Outer Loop (OL)

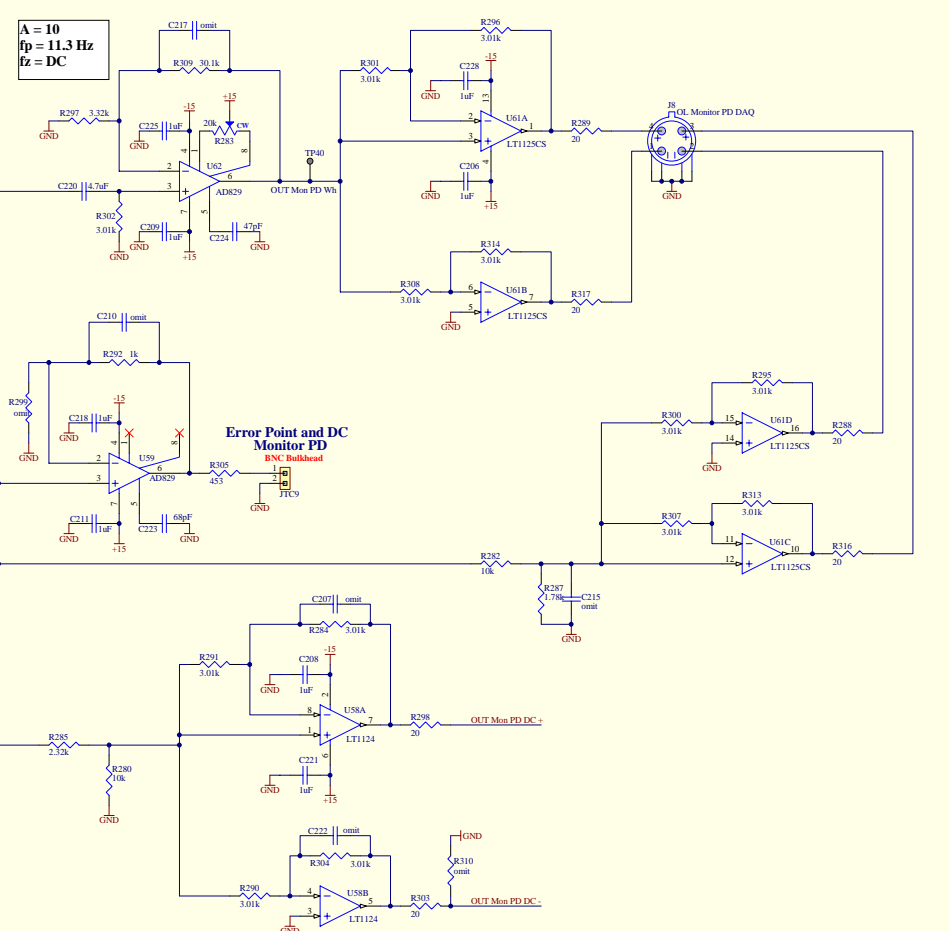
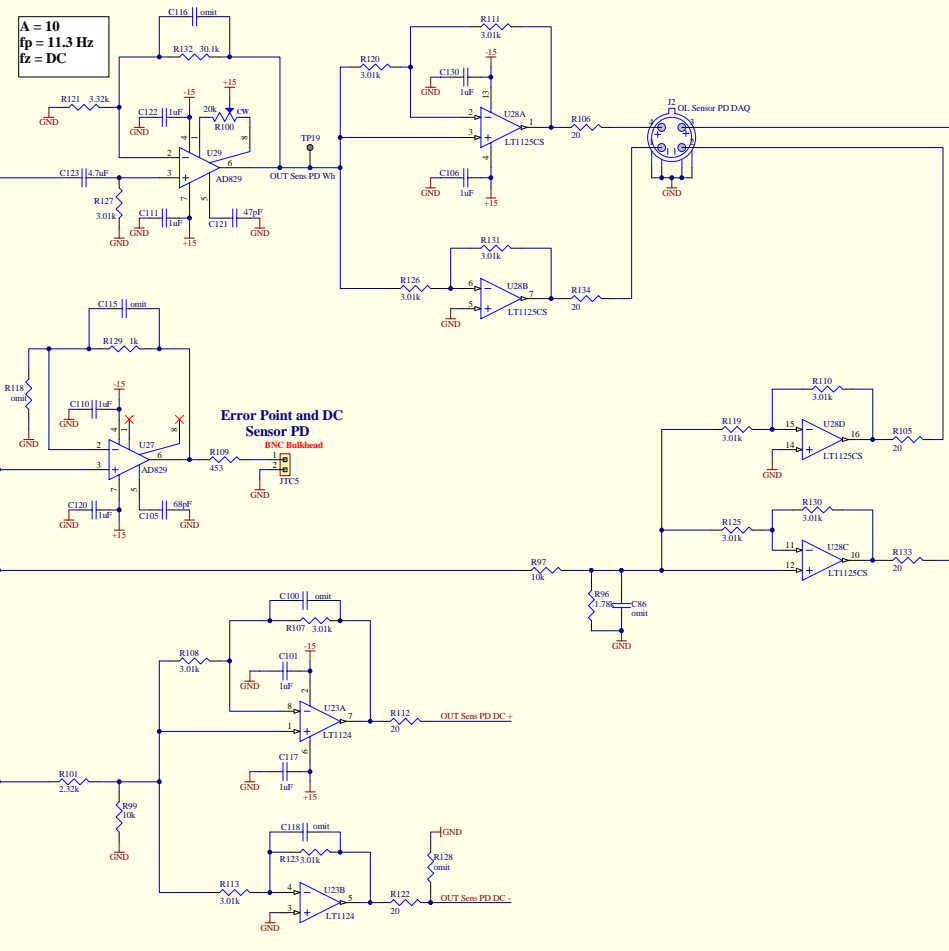
This wire-wrapped crossing is temporary. It will be removed as soon as we will have the revised PD head (including a differential driver)
